## **Staff Changes**

This section covers changes proposed by Planning Staff to correct errors and to reflect changes in conversion philosophy based on discussions with the PHED Committee and the Planning Board.

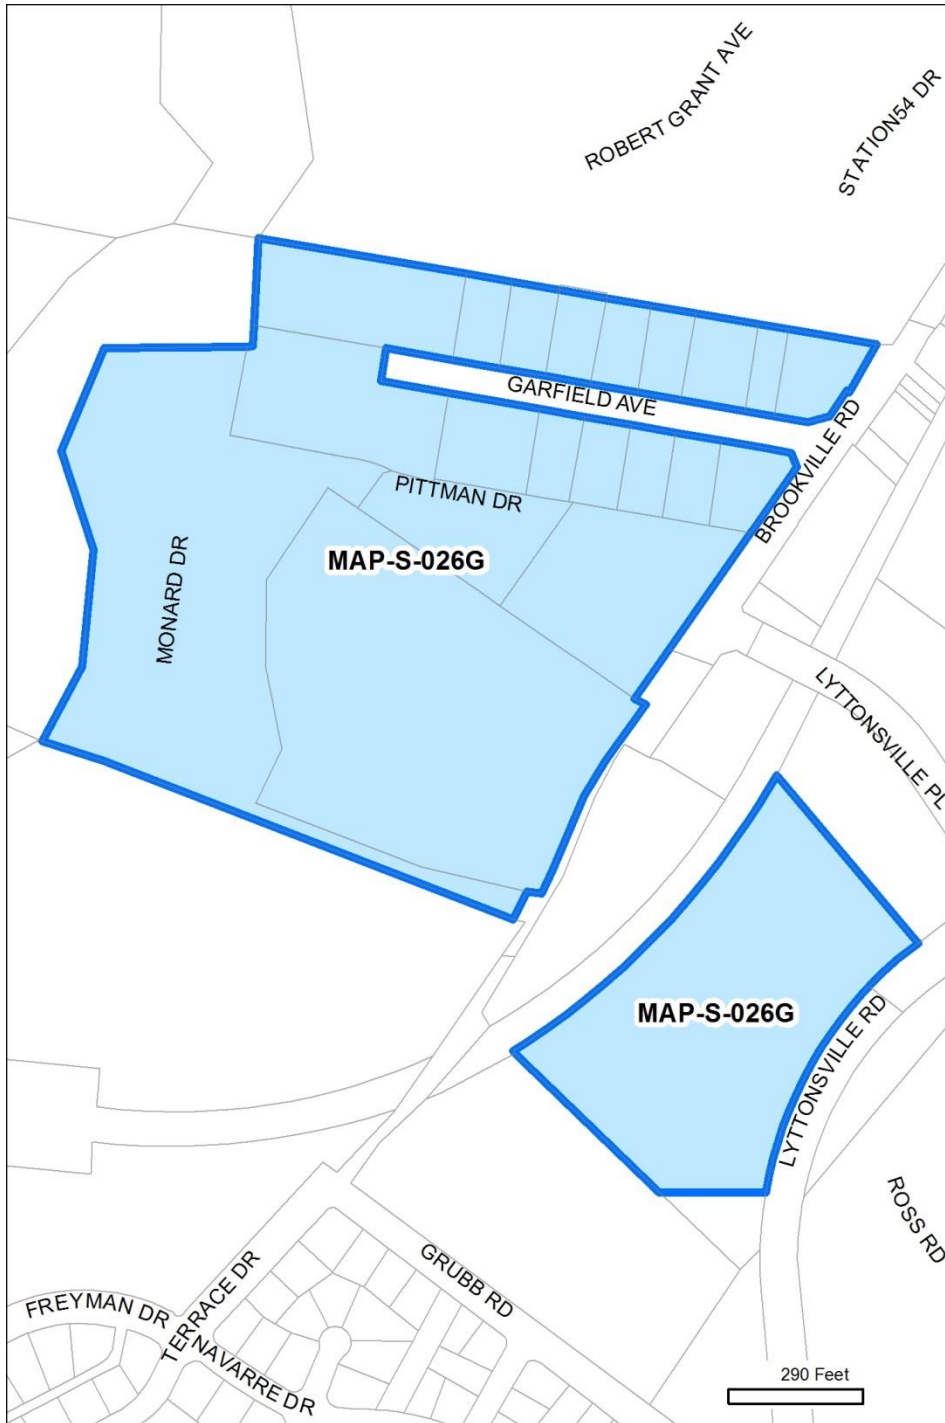
<b>Unique ID:</b> MAP-S-026G		staff rec. change
<b>Master Plan ID:</b> n/a		
<b>Master Plan:</b>	North and West Silver Spring	
<b>Location:</b>		
<b>Existing Zone:</b>	I-1	
<b>Proposed Conv:</b> (5/2)	<del>IM-2.5 H-120</del>	
<b>Prop. Revised Conv:</b>	IM-2.5 H-50	
<b>Category:</b>	Staff Recommendation	
<b>Modifications</b>	<b>Zone Group:</b>	No change
	<b>Overall FAR:</b>	No change
	<b>Comm'l FAR:</b>	-
	<b>Resid'l FAR:</b>	-
	<b>Height:</b>	Reduced to 50'
<b>Reason for change:</b>		
<p><i>Since the 5/2 conversion was approved by the Planning Board, staff has received comment from the public and upon further review, believes that the 120' height granted as part of the 5/2 conversion is inappropriate.</i></p> <p><i>The current zoning ordinance allows building heights up to 120' for an "Employment Center", unless the master plan specifically states that an "Employment Center" is inappropriate for the zone – only two master plans contain this restriction.</i></p> <p><i>This provision has been in the code since the last comprehensive revision. Further analysis indicates that buildings up to 120' have not been constructed in the I-1 zone under this provision. Staff proposes a height of 50' for all I-1 property converted to the I-M zone.</i></p>

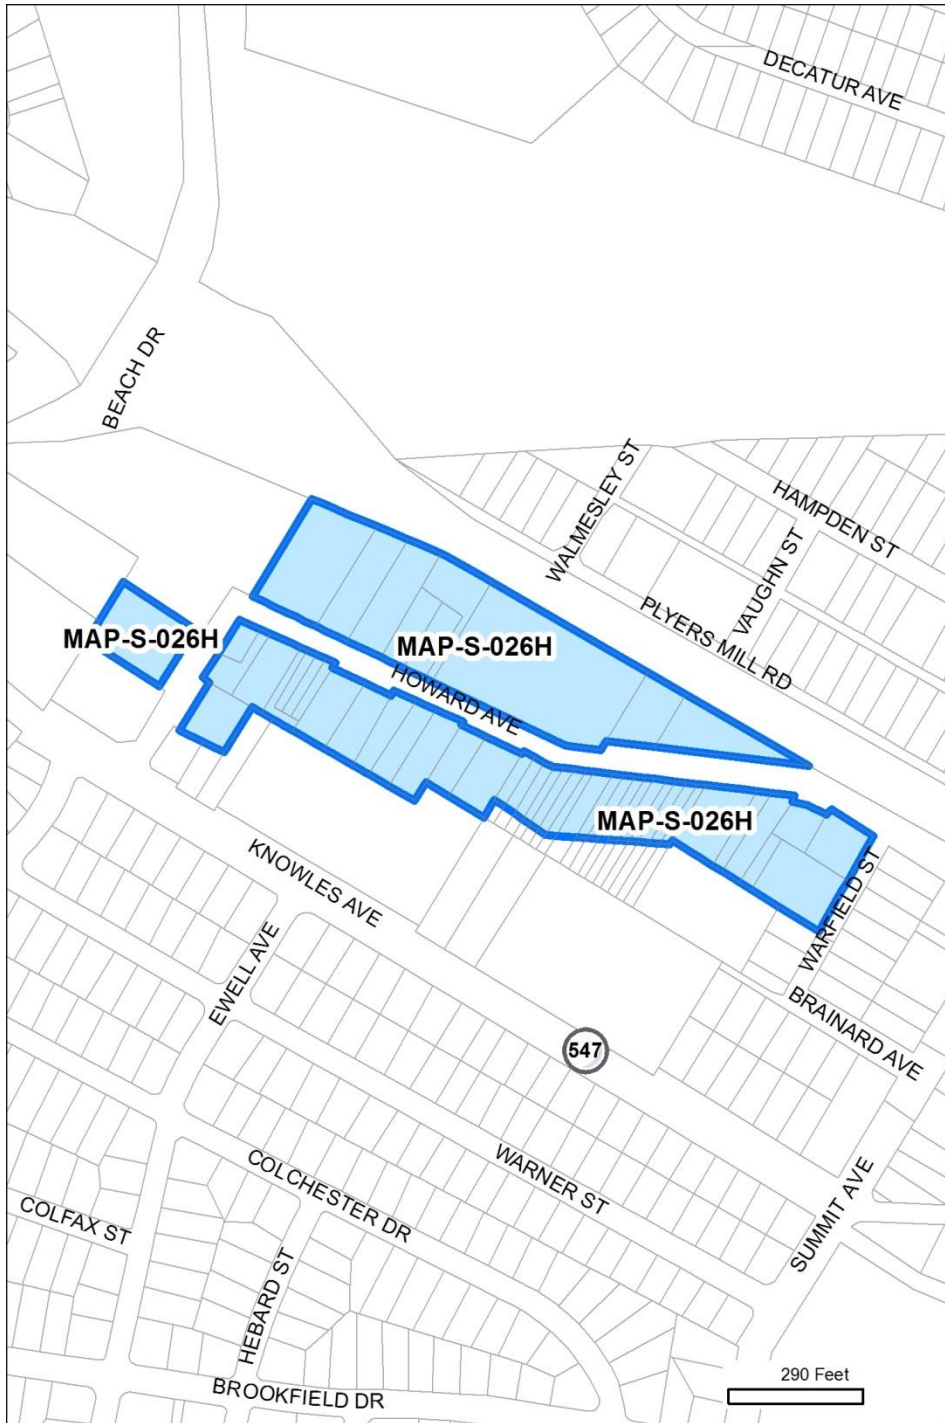
<b>Unique ID:</b> MAP-S-026H		staff rec. change
<b>Master Plan ID:</b> n/a		
<b>Master Plan:</b>	Kensington	
<b>Location:</b>		
<b>Existing Zone:</b>	I-1	
<b>Proposed Conv:</b> (5/2)	<del>IM-2.5 H-120</del>	
<b>Prop. Revised Conv:</b>	IM-2.5 H-50	
<b>Category:</b>	Staff Recommendation	
<b>Modifications</b>	<b>Zone Group:</b>	No change
	<b>Overall FAR:</b>	No change
	<b>Comm'l FAR:</b>	-
	<b>Resid'l FAR:</b>	-
	<b>Height:</b>	Reduced to 50'
<b>Reason for change:</b>		
<p><i>Since the 5/2 conversion was approved by the Planning Board, staff has received comment from the public and upon further review, believes that the 120' height granted as part of the 5/2 conversion is inappropriate.</i></p> <p><i>The current zoning ordinance allows building heights up to 120' for an "Employment Center", unless the master plan specifically states that an "Employment Center" is inappropriate for the zone – only two master plans contain this restriction.</i></p> <p><i>This provision has been in the code since the last comprehensive revision. Further analysis indicates that buildings up to 120' have not been constructed in the I-1 zone under this provision. Staff proposes a height of 50' for all I-1 property converted to the I-M zone.</i></p>

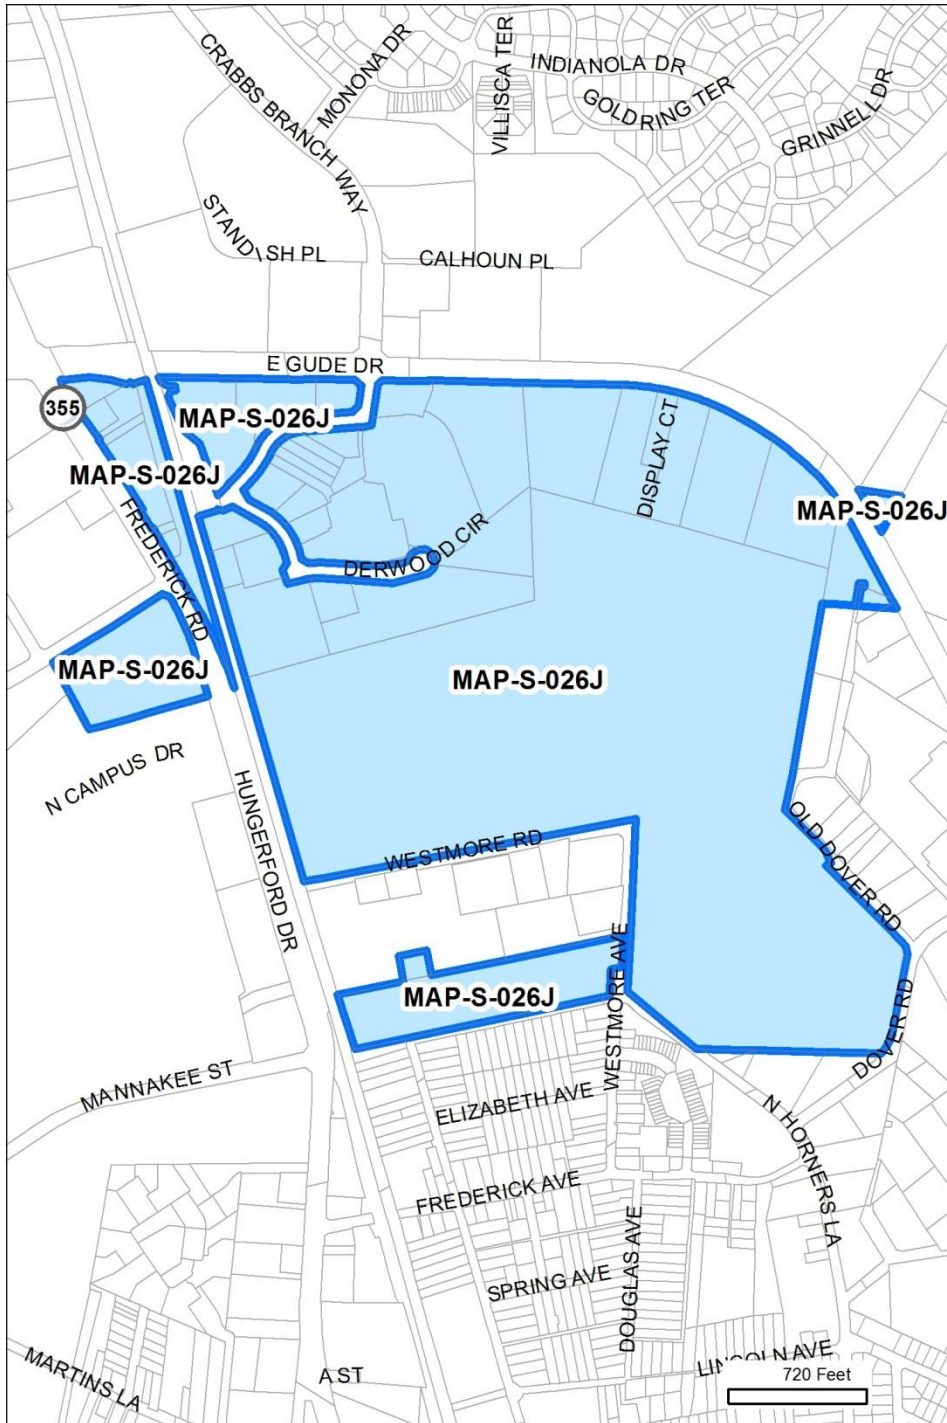
<b>Unique ID:</b> MAP-S-026J		staff rec. change
<b>Master Plan ID:</b> n/a		
<b>Master Plan:</b>	Upper Rock Creek / Shady Grove	
<b>Location:</b>		
<b>Existing Zone:</b>	I-1	
<b>Proposed Conv: (5/2)</b>	<del>IM-2.5 H-120</del>	
<b>Prop. Revised Conv:</b>	IM-2.5 H-50	
<b>Category:</b>	Staff Recommendation	
<b>Modifications</b>	<b>Zone Group:</b>	No change
	<b>Overall FAR:</b>	No change
	<b>Comm'l FAR:</b>	-
	<b>Resid'l FAR:</b>	-
	<b>Height:</b>	Reduced to 50'
<b>Reason for change:</b>		
<p>Since the 5/2 conversion was approved by the Planning Board, staff has received comment from the public and upon further review, believes that the 120' height granted as part of the 5/2 conversion is inappropriate.</p> <p>The current zoning ordinance allows building heights up to 120' for an "Employment Center", unless the master plan specifically states that an "Employment Center" is inappropriate for the zone – only two master plans contain this restriction.</p> <p>This provision has been in the code since the last comprehensive revision. Further analysis indicates that buildings up to 120' have not been constructed in the I-1 zone under this provision. Staff proposes a height of 50' for all I-1 property converted to the I-M zone.</p>

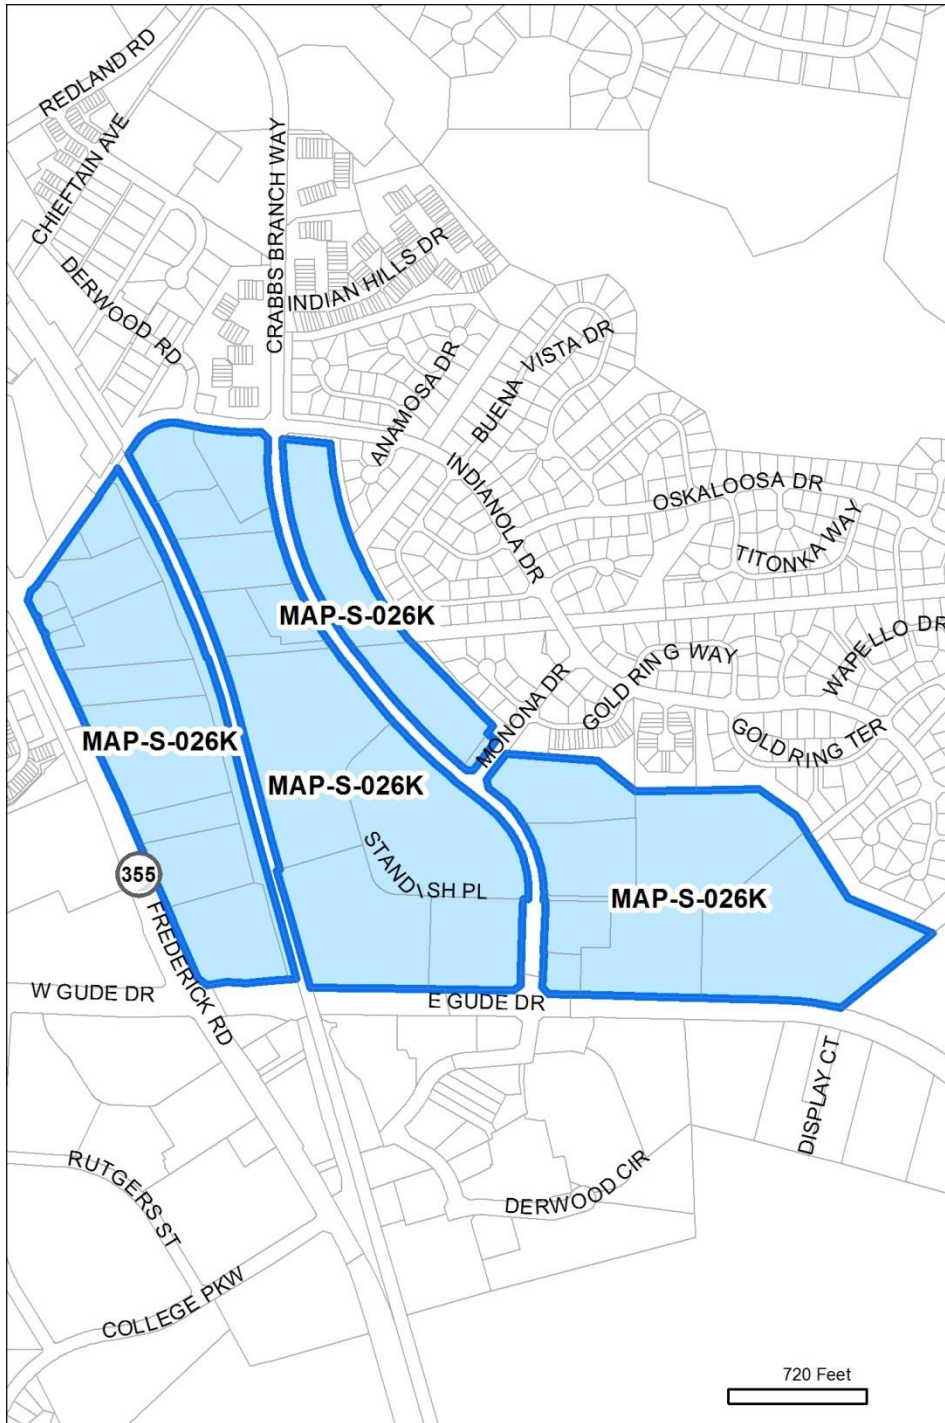
<b>Unique ID:</b> MAP-S-026K		staff rec. change
<b>Master Plan ID:</b> n/a		
<b>Master Plan:</b>		Shady Grove
<b>Location:</b>		
<b>Existing Zone:</b>		I-1
<b>Proposed Conv: (5/2)</b>		<del>IM-2.5 H-120</del>
<b>Prop. Revised Conv:</b>		IM-2.5 H-50
<b>Category:</b>		Staff Recommendation
<b>Modifications</b>	<b>Zone Group:</b>	No change
	<b>Overall FAR:</b>	No change
	<b>Comm'l FAR:</b>	-
	<b>Resid'l FAR:</b>	-
	<b>Height:</b>	Reduced to 50'
<b>Reason for change:</b>		
<p>Since the 5/2 conversion was approved by the Planning Board, staff has received comment from the public and upon further review, believes that the 120' height granted as part of the 5/2 conversion is inappropriate.</p> <p>The current zoning ordinance allows building heights up to 120' for an "Employment Center", unless the master plan specifically states that an "Employment Center" is inappropriate for the zone – only two master plans contain this restriction.</p> <p>This provision has been in the code since the last comprehensive revision. Further analysis indicates that buildings up to 120' have not been constructed in the I-1 zone under this provision. Staff proposes a height of 50' for all I-1 property converted to the I-M zone.</p>

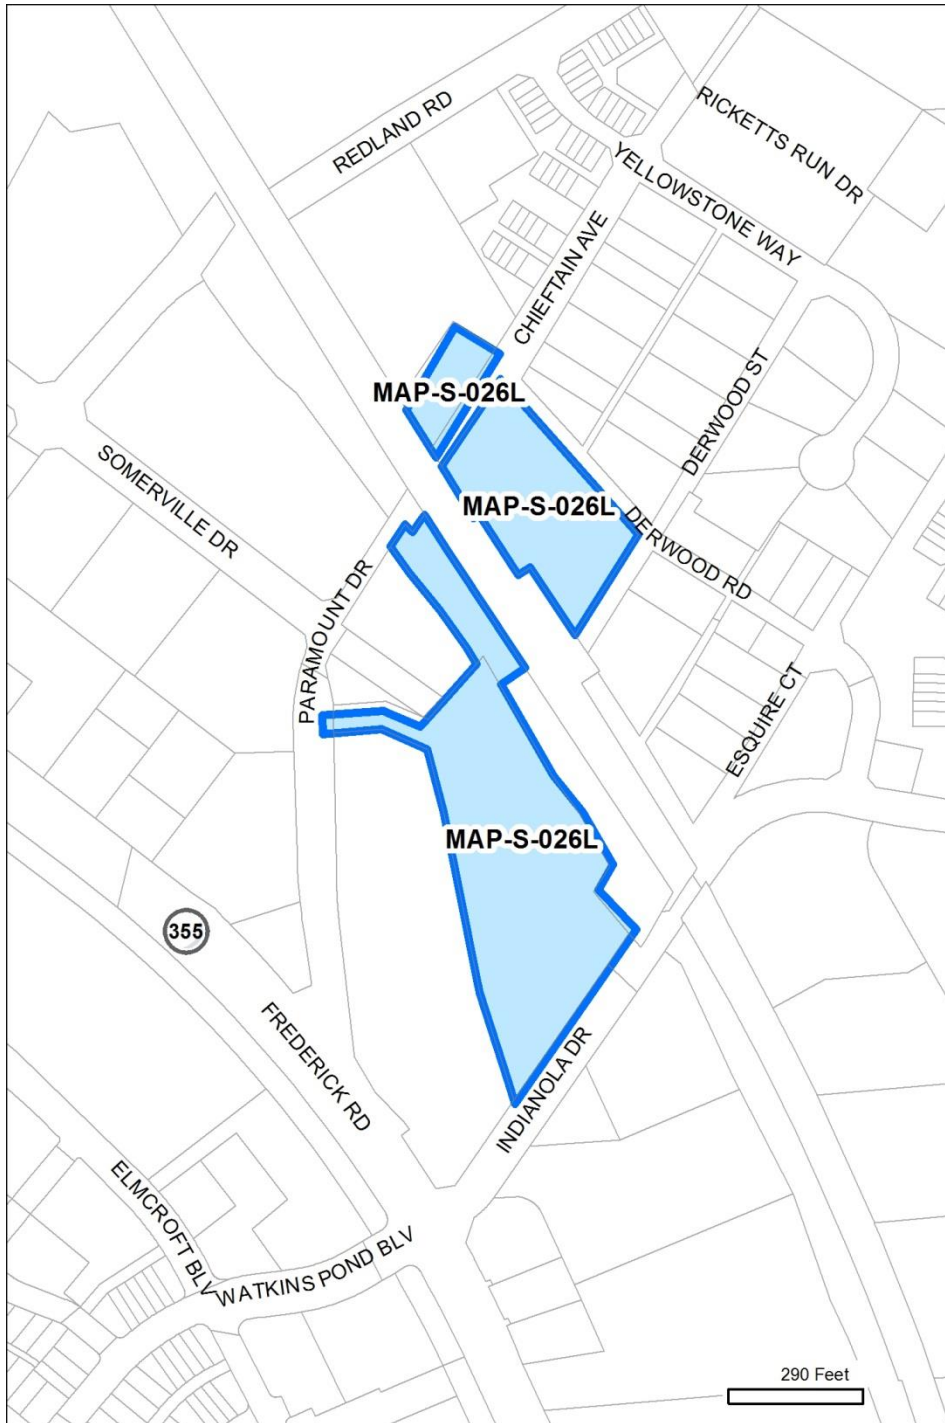
<b>Unique ID:</b> MAP-S-026L		staff rec. change
<b>Master Plan ID:</b> n/a		
<b>Master Plan:</b>	Shady Grove	
<b>Location:</b>		
<b>Existing Zone:</b>	I-1	
<b>Proposed Conv:</b> (5/2)	<del>IM-2.5 H-120</del>	
<b>Prop. Revised Conv:</b>	IM-2.5 H-50	
<b>Category:</b>	Staff Recommendation	
<b>Modifications</b>	<b>Zone Group:</b>	No change
	<b>Overall FAR:</b>	No change
	<b>Comm'l FAR:</b>	-
	<b>Resid'l FAR:</b>	-
	<b>Height:</b>	Reduced to 50'
<b>Reason for change:</b>		
<p><i>Since the 5/2 conversion was approved by the Planning Board, staff has received comment from the public and upon further review, believes that the 120' height granted as part of the 5/2 conversion is inappropriate.</i></p> <p><i>The current zoning ordinance allows building heights up to 120' for an "Employment Center", unless the master plan specifically states that an "Employment Center" is inappropriate for the zone – only two master plans contain this restriction.</i></p> <p><i>This provision has been in the code since the last comprehensive revision. Further analysis indicates that buildings up to 120' have not been constructed in the I-1 zone under this provision. Staff proposes a height of 50' for all I-1 property converted to the I-M zone.</i></p>

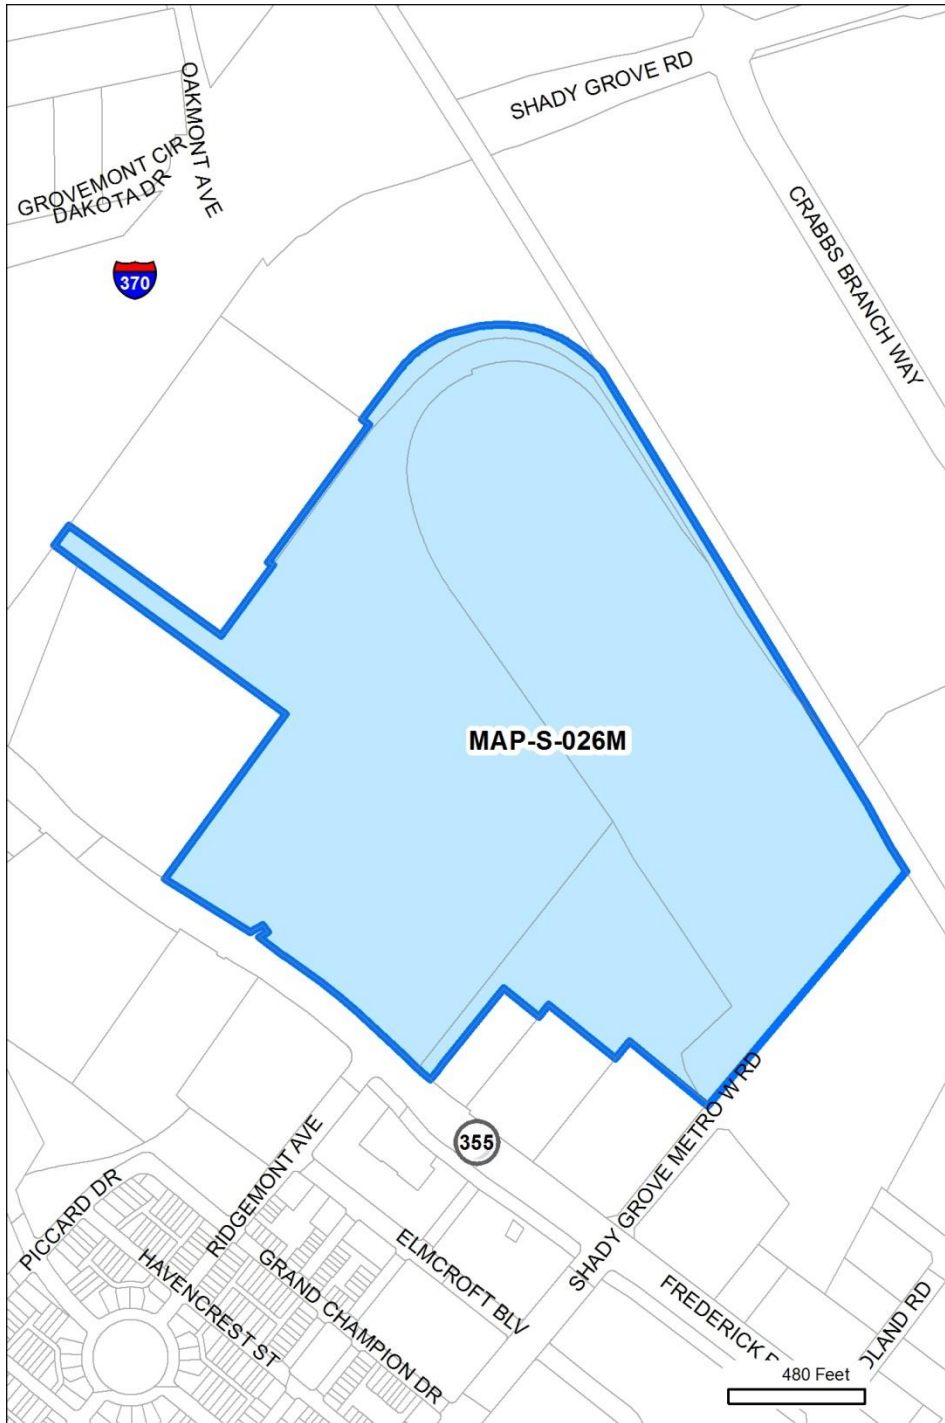
<b>Unique ID:</b> MAP-S-026M		staff rec. change
<b>Master Plan ID:</b> n/a		
<b>Master Plan:</b>		Shady Grove
<b>Location:</b>		
<b>Existing Zone:</b>		I-1
<b>Proposed Conv: (5/2)</b>		<del>IM-2.5 H-120</del>
<b>Prop. Revised Conv:</b>		IM-2.5 H-50
<b>Category:</b>		Staff Recommendation
<b>Modifications</b>	<b>Zone Group:</b>	No change
	<b>Overall FAR:</b>	No change
	<b>Comm'l FAR:</b>	-
	<b>Resid'l FAR:</b>	-
	<b>Height:</b>	Reduced to 50'
<b>Reason for change:</b>		
<p><i>Since the 5/2 conversion was approved by the Planning Board, staff has received comment from the public and upon further review, believes that the 120' height granted as part of the 5/2 conversion is inappropriate.</i></p> <p><i>The current zoning ordinance allows building heights up to 120' for an "Employment Center", unless the master plan specifically states that an "Employment Center" is inappropriate for the zone – only two master plans contain this restriction.</i></p> <p><i>This provision has been in the code since the last comprehensive revision. Further analysis indicates that buildings up to 120' have not been constructed in the I-1 zone under this provision. Staff proposes a height of 50' for all I-1 property converted to the I-M zone.</i></p>
